Origination Form
Proposed Revisions to a Standard Plans Index

Originator:	Holley, Tim	Index Number:	425-015
Date:	7/1/2026	Sheet Number(s):	1-2
E-mail:	Tim.Holley@dot.state.fl.us	Index Title:	Manhole Tops

The manhole top and cover information from 425-001 is being moved to a new Index: 425-015.

MANHOLE TOPS

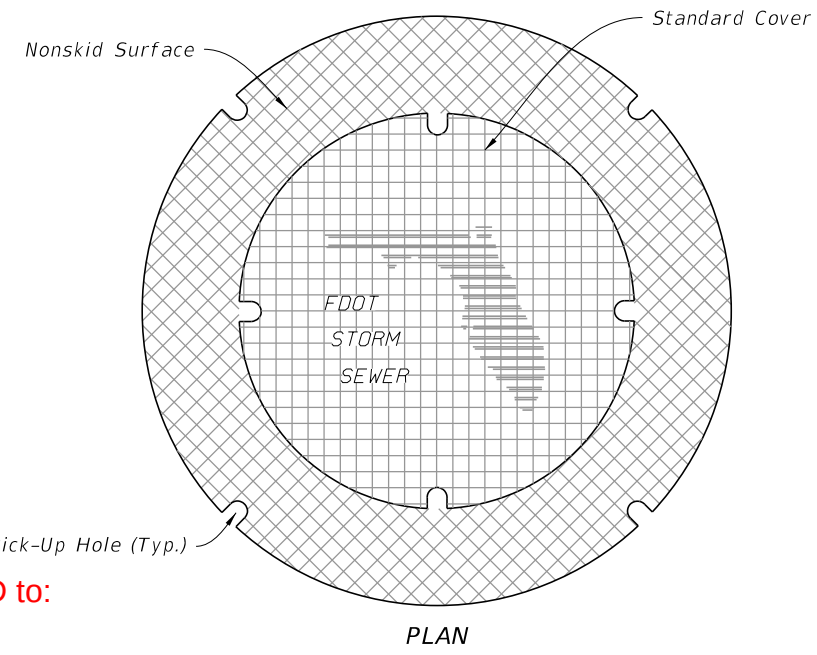
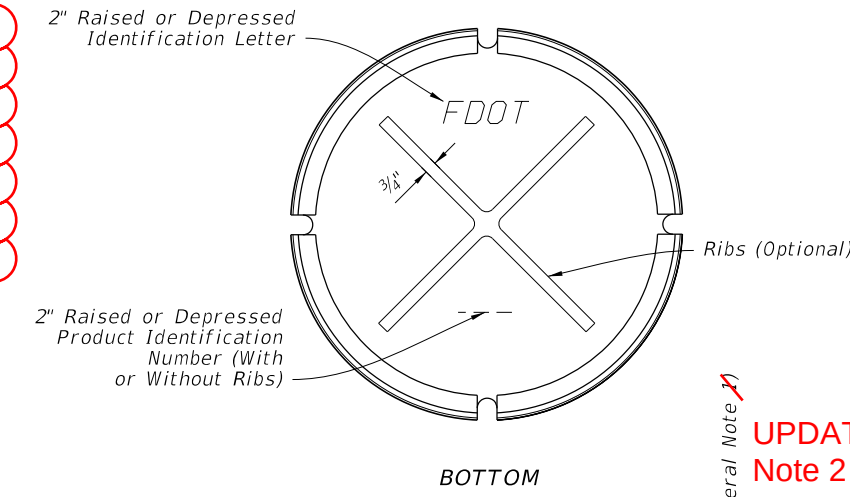
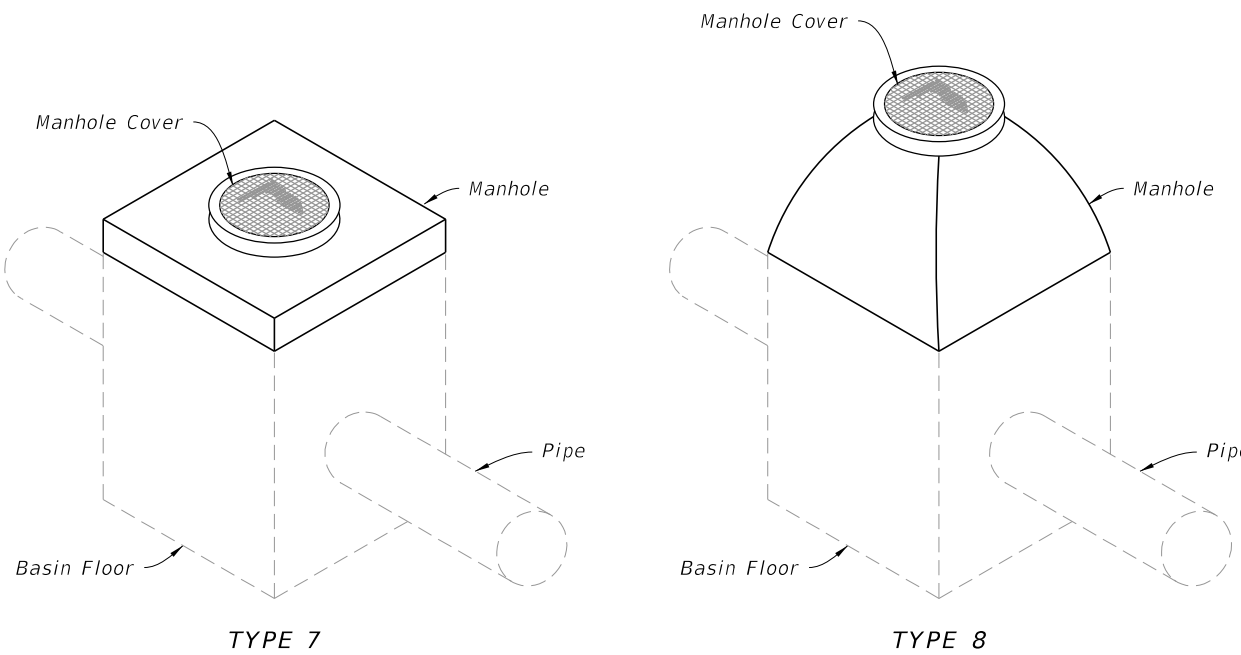
NEW INDEX 425-015

UPDATED to:
Note 3

UPDATED to:
Note 2

CHANGED to:
"MANHOLE RIGID FRAMES"

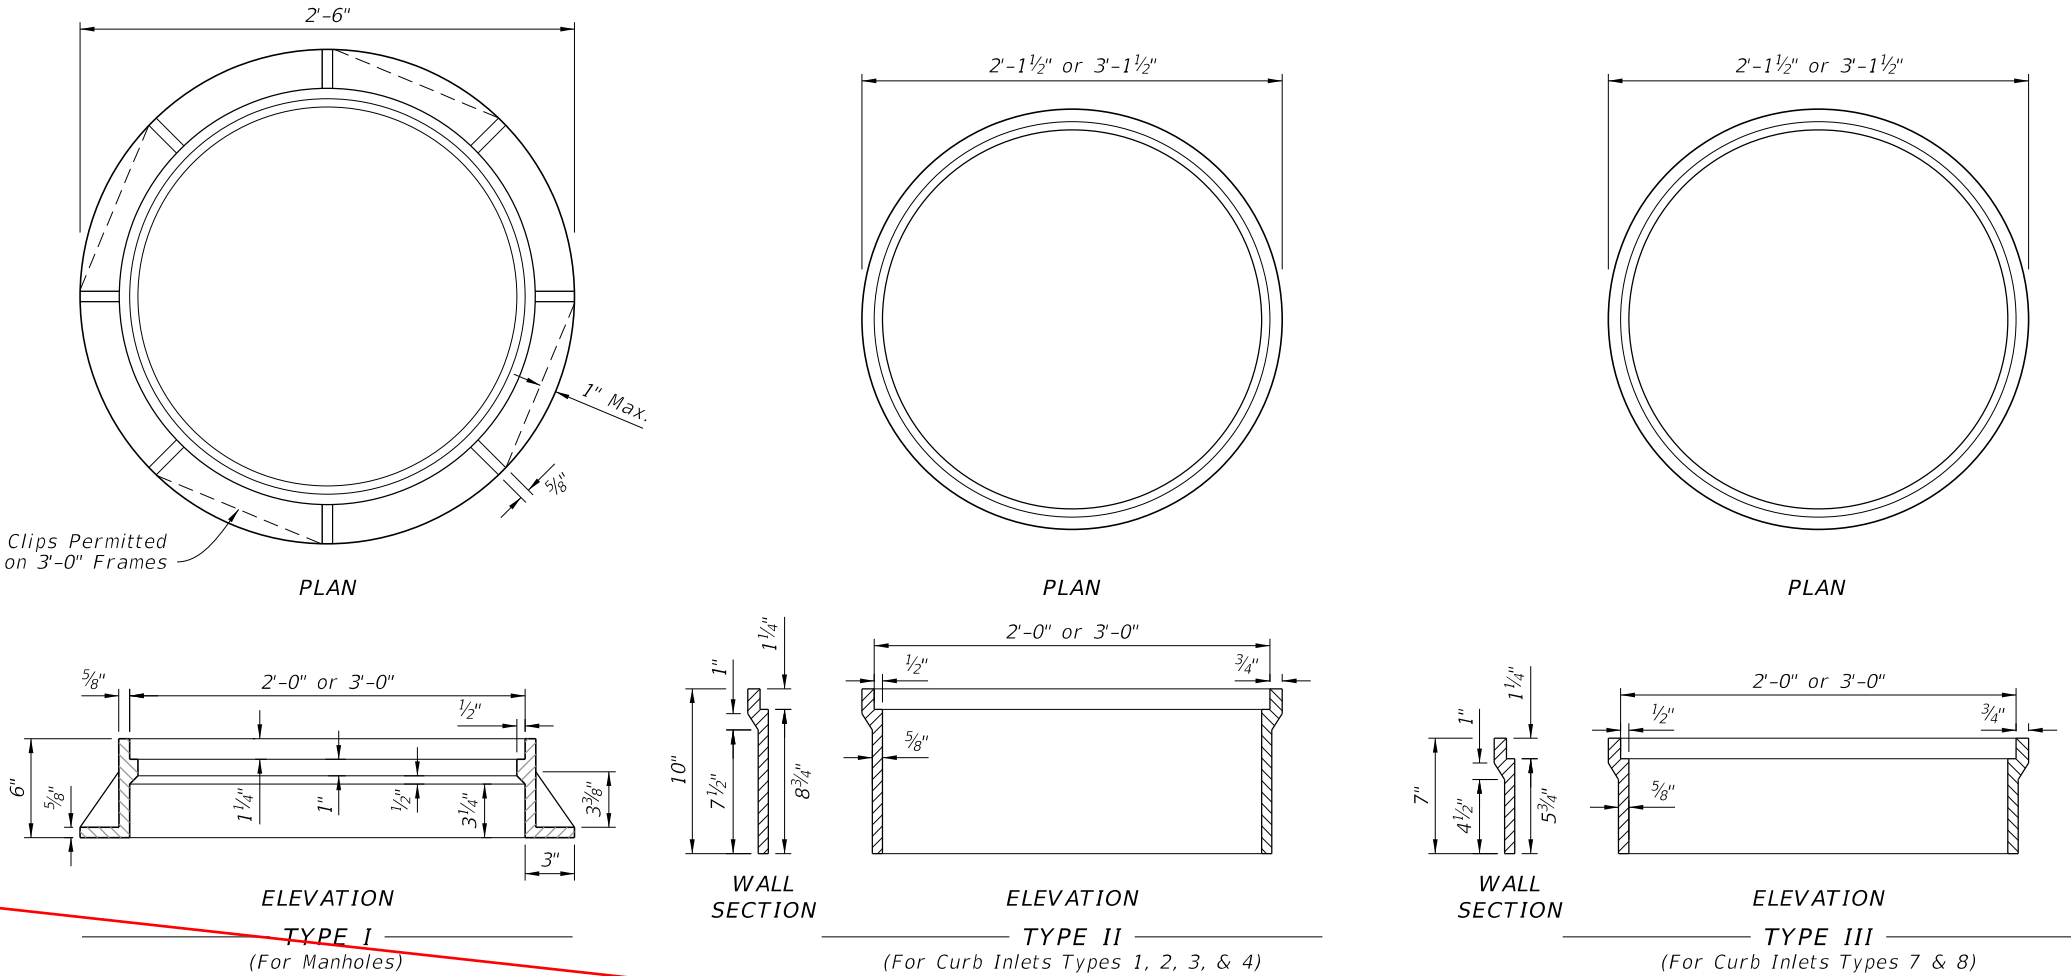
~~MANHOLE FRAMES~~

MANHOLE TOPS

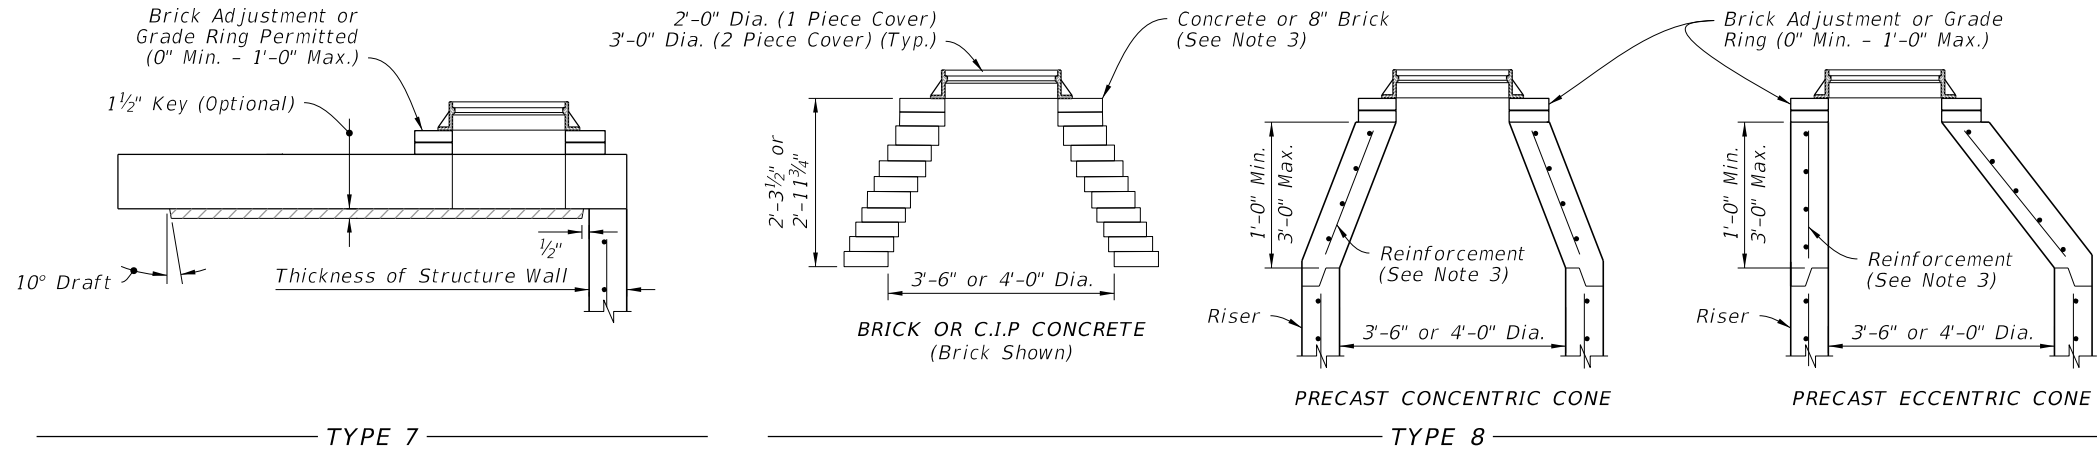
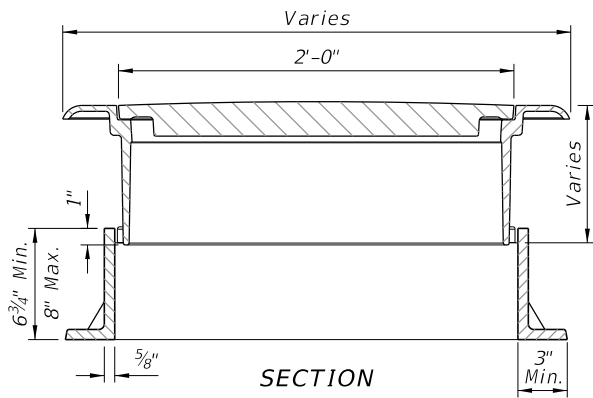
UPDATED to:
"in Index 425-001"

CHANGED TO;
optional construction joints
